APPEAL SUMMARY

Appeal ID: 20796	Project Address: 3500 NE MLK Jr Blvd
Hearing Date: 8/28/19	Appellant Name: Krista Pettis
Case No.: B-006	Appellant Phone: 5035393858
Appeal Type: Building	Plans Examiner/Inspector: David Bartley
Project Type: commercial	Stories: 2 Occupancy: B Construction Type: V-B
Building/Business Name: Timber Dental	Fire Sprinklers: Yes - Throughout
Appeal Involves: Alteration of an existing structure LUR or Permit Application No.: 19-200911-CO	
Plan Submitted Option: pdf [File 1] [File 2]	Proposed use: Dental Office

APPEAL INFORMATION SHEET

PLUMBING FIXTURES

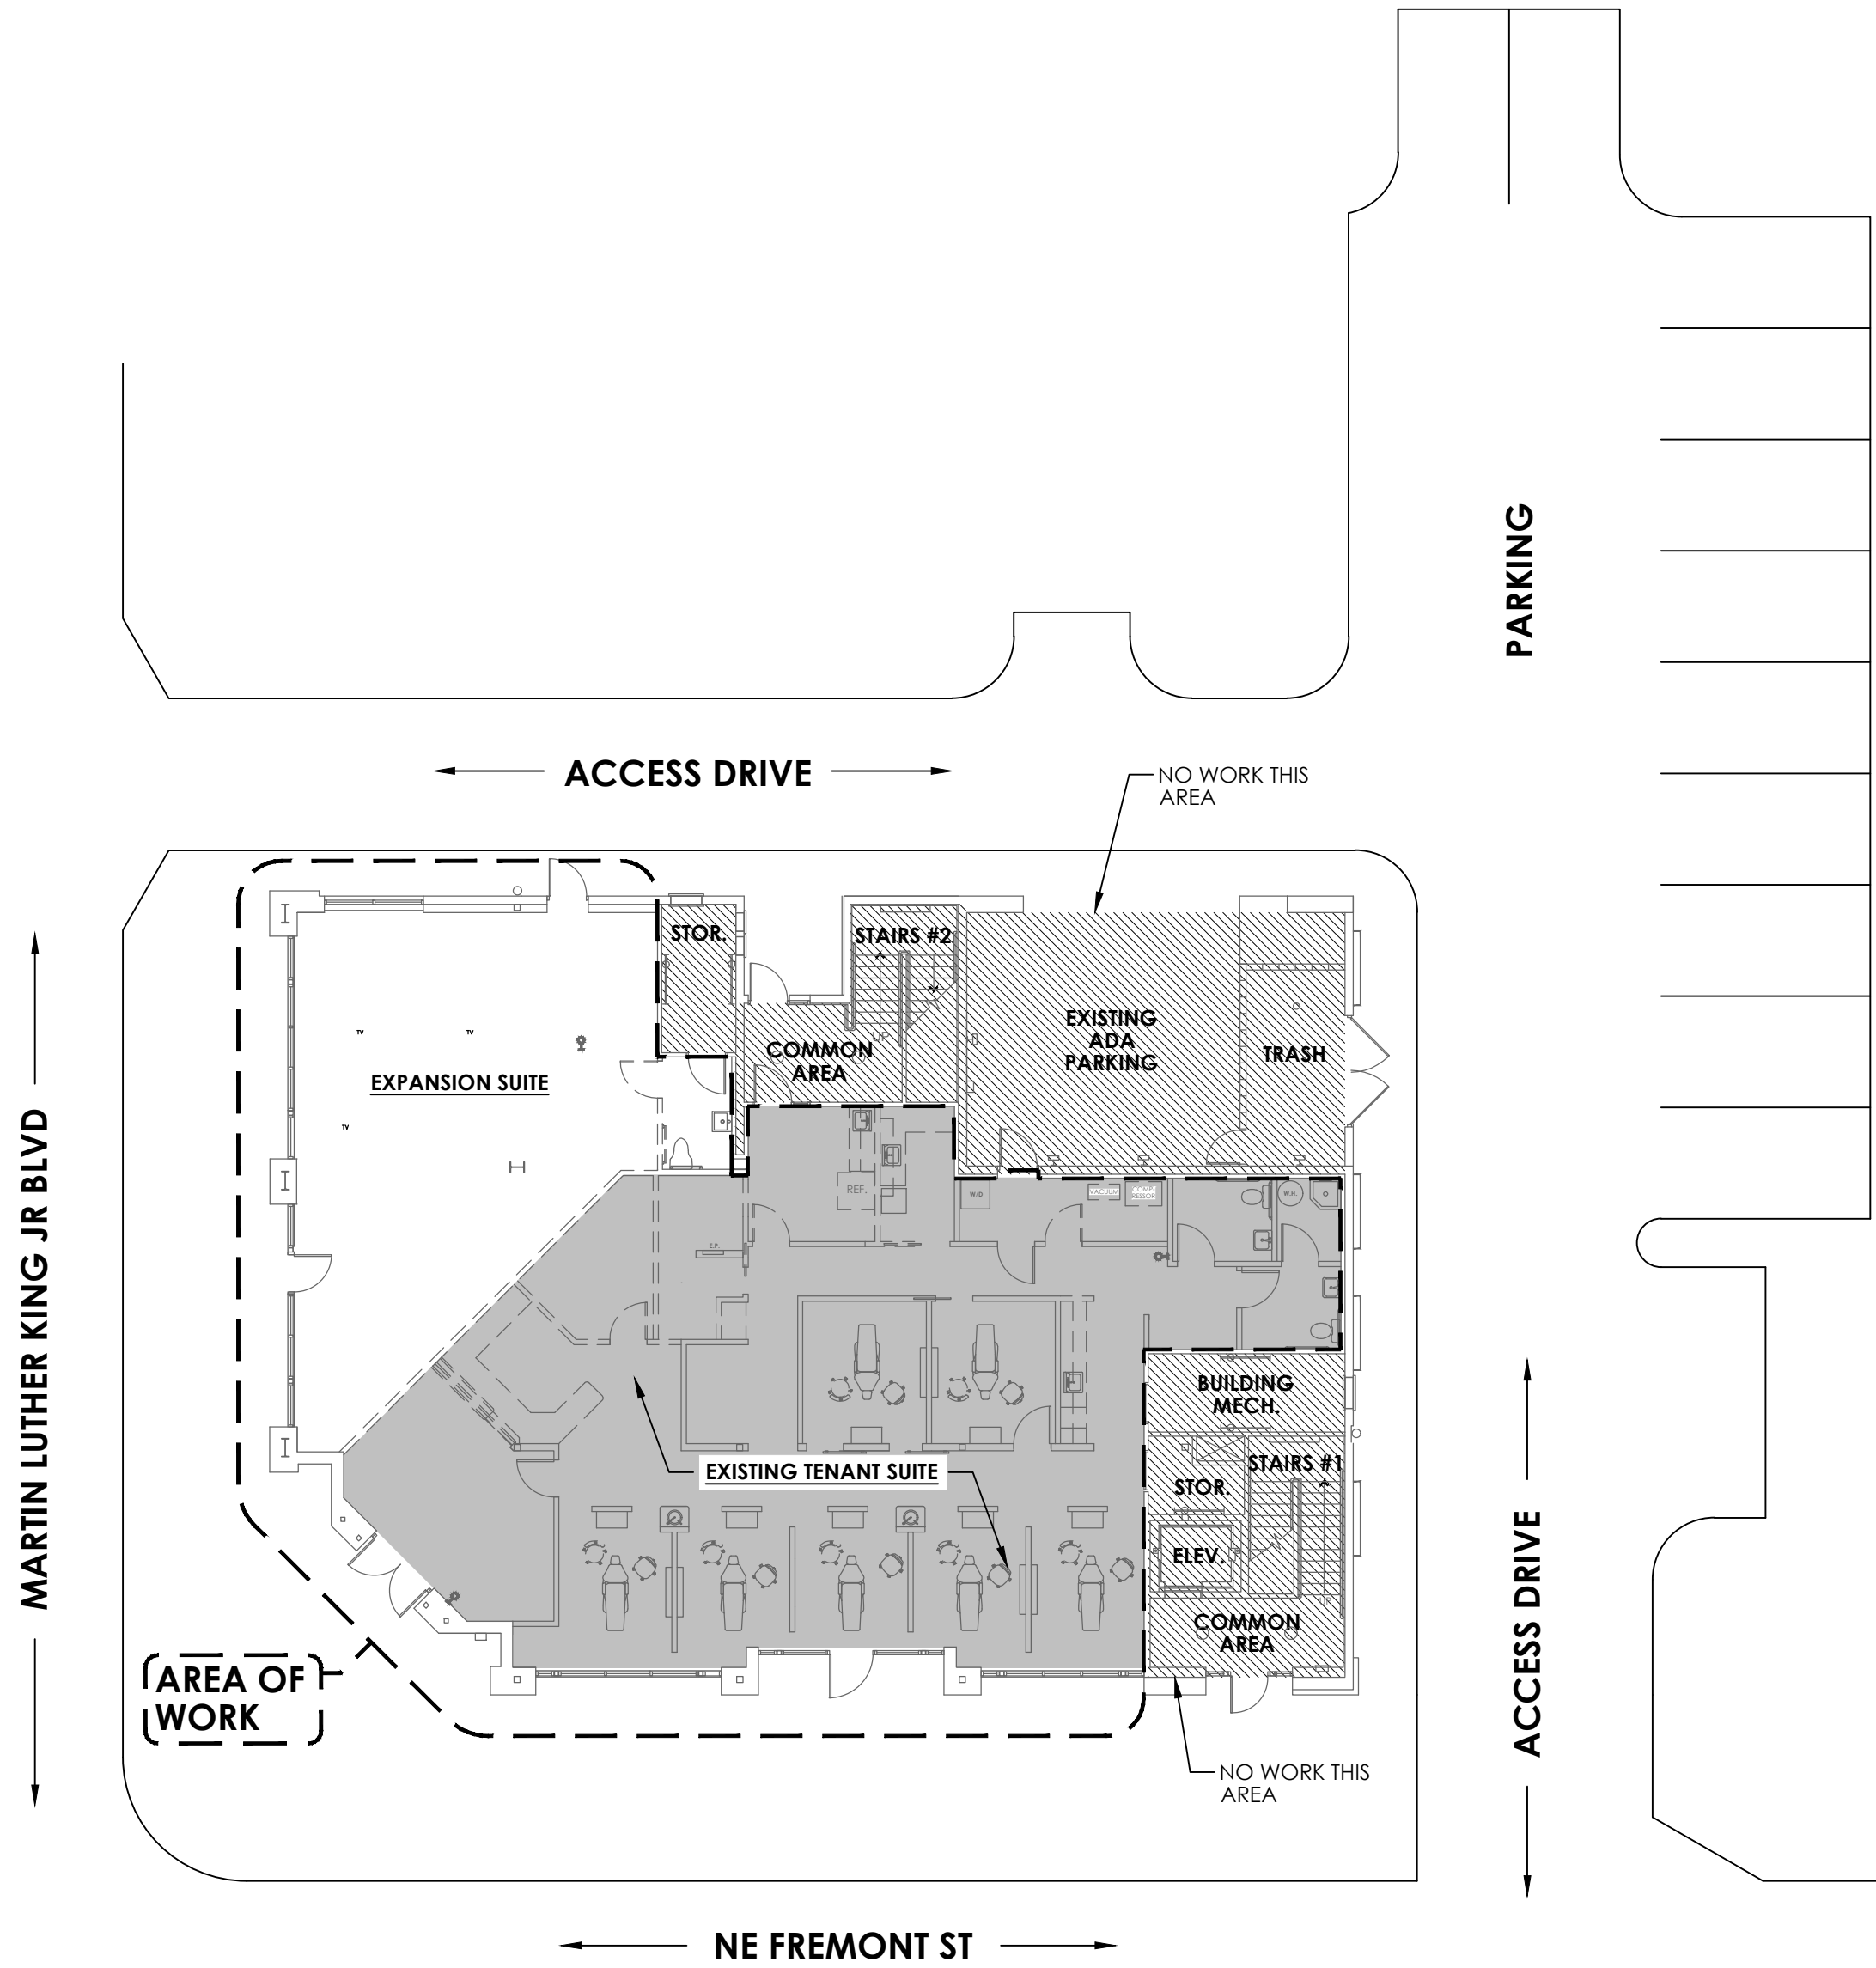
Appeal item 1

Code Section 1004, 2902.2

Requires According to Table 2902.1 Minimum Number of Required Plumbing Fixtures:

Separate Facilities are required, meaning that the overall occupant load is divided evenly between men and women, then required fixtures are calculated for each. Single-user restrooms can replace required fixtures, but must still provide the same number of fixtures required by calculation.

Proposed Design The current project under review provides three unisex restrooms which according to Chapter 29 table 2902.1 provide restrooms for a theoretical total of 100 occupants or 50 males and 50 females.

We kindly request acceptance of the current proposed three unisex restrooms distributed throughout the space to best serve the users and the staff.

We are requesting a modification to the plumbing fixture calculations based on the following:

The Timber Dental Project has an egress occupancy of 59 occupants. This may be reduced by 15 since the Staff Break Room is used by Staff already counted with the overall occupancy load which results in a total plumbing occupancy of 44 or 22 females and 22 males. Calculated separately the 44 occupants would require one unisex restrooms each for a total of two restrooms. Currently the two restrooms in the existing space are adequate for the number of staff and patients using the space.

Based on the actual use of the dental clinic, as noted in the attached memo from the owner, and history since opening, we anticipate a maximum total occupant load at any time of 24 which includes full-time staff plus the number of patients and accompanying guests or family members each hour throughout the day. Assuming a worst-case scenario where this number is doubled that would result in a total of 48 total occupants or 24 female and 24 male occupants. This would require one restroom each for a total of two.

In chapter 29 of the Oregon Specialty Code, under 2902.1 Fixture Calculations, there is an exception that reads:

“Exception: The total occupant load shall not be required to be divided in half where approved statistical data indicate a distribution of the sexes of other than 50 percent of each sex.”

In the 2016 US Department of Labor the percentage of women practicing dentistry is 30%, but the rest of the staff is over 90% female by profession. Receptionists (90.1%), Administrative (94.4%), Dental Hygienists (97.1%), Dental assistants (93.3%). Source: US Department of Labor as referenced here: <https://www.bostonglobe.com/metro/2017/03/06/chart-the-percentage-women-and-men-each-profession/GBX22YsWI0XaeHghwXfE4H/story.html>.

1. Reduction in minimum required plumbing fixture count: Granted as proposed for this use and configuration.

2 EGRESS PLAN

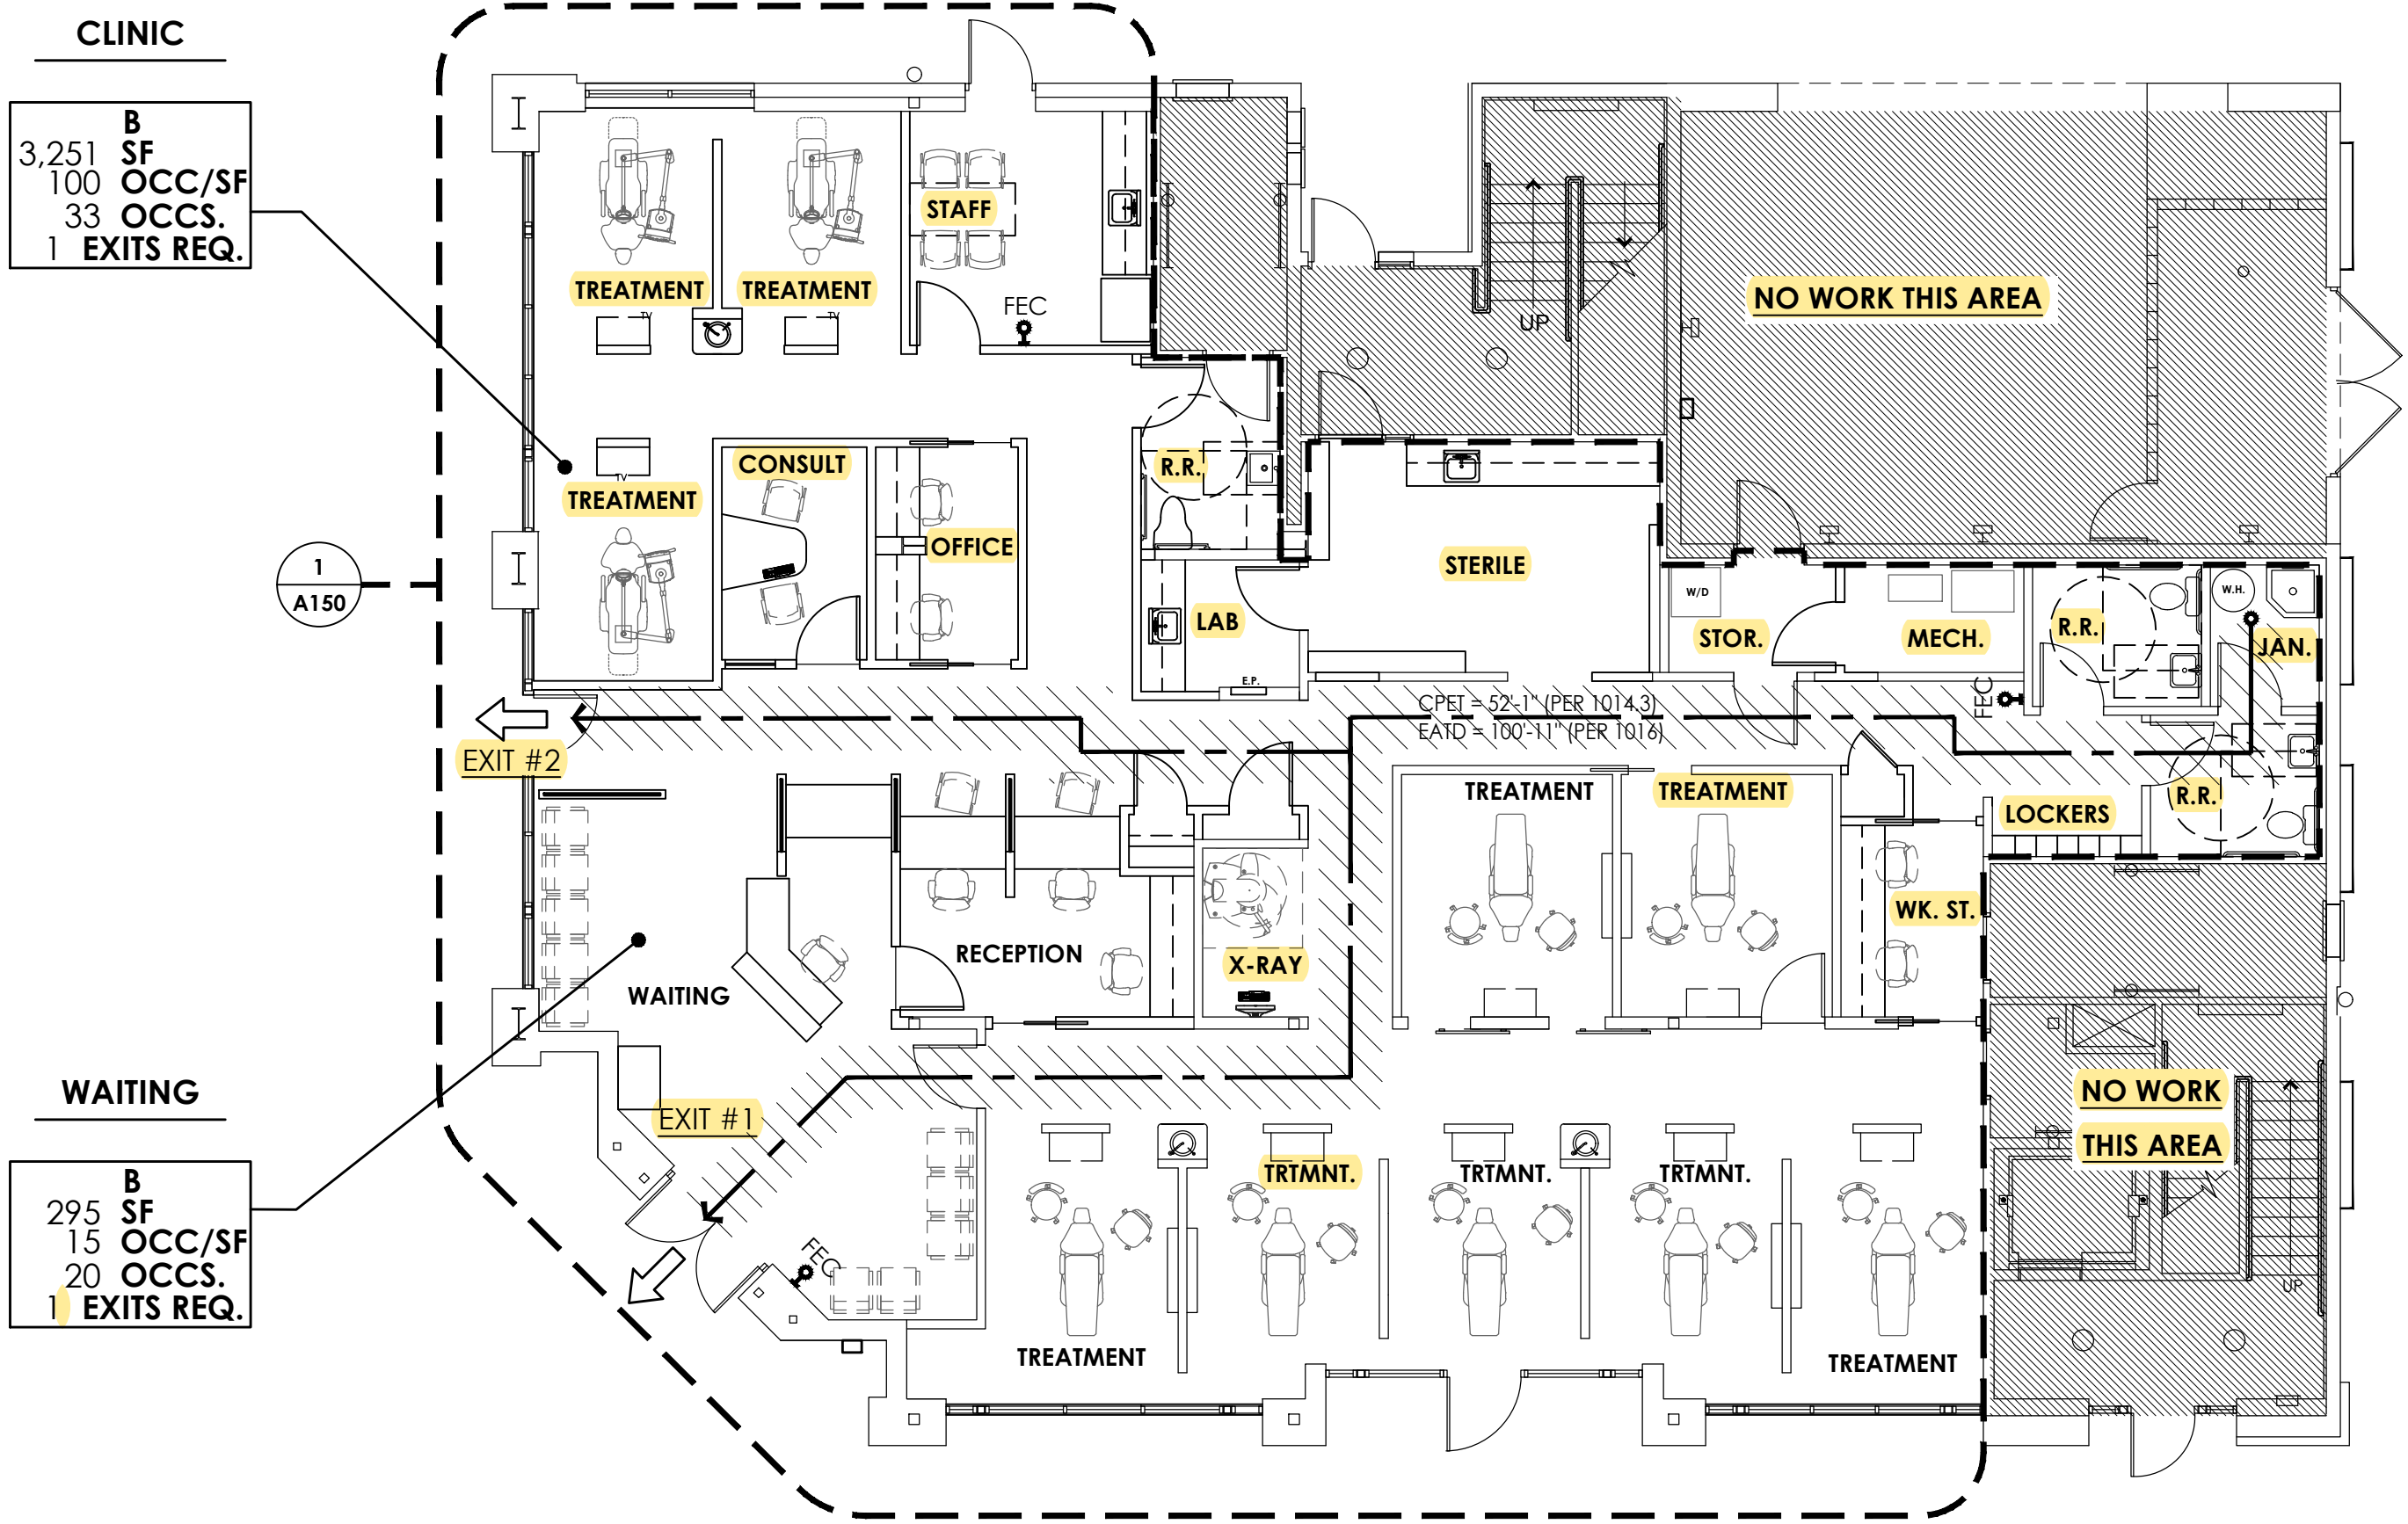
Appeal item 2

Code Section	1004.1.2, 1015.1
---------------------	------------------

Requires	If more than one exit is required, the exits are required to be separated by no less than one-third the diagonal dimension of the areas served. If occupant load is more than 50, two exits are required.
-----------------	---

Proposed Design	We are requesting a modification to the occupancy calculation, reducing the number of occupants to 44 and therefore a modification to the required exit calculation to be one exit required.
------------------------	--

Reason for alternative The Timber Dental Project has an egress occupancy of 59 occupants. This may be reduced by 15 since the Staff Break Room is used by Staff already counted with the overall occupancy load which results in a total occupancy of 44. 44 Users would require only one exit.

Based on the actual use of the dental clinic, as noted in the attached memo from the owner, and history since opening, we anticipate a maximum total occupant load at any time of 24 which includes full-time staff plus the number of patients and accompanying guests or family members each hour throughout the day. Assuming a worst-case scenario where this number is doubled that would result in a total of 48 total occupants or 24 female and 24 male occupants. This would require one exit.

Two exits are provided. There location is 86.5% of the required separation distance if two exits are required.

2. Reduction in calculated occupant load to allow a single exit: Denied. Proposal does not provide equivalent Life Safety protection.
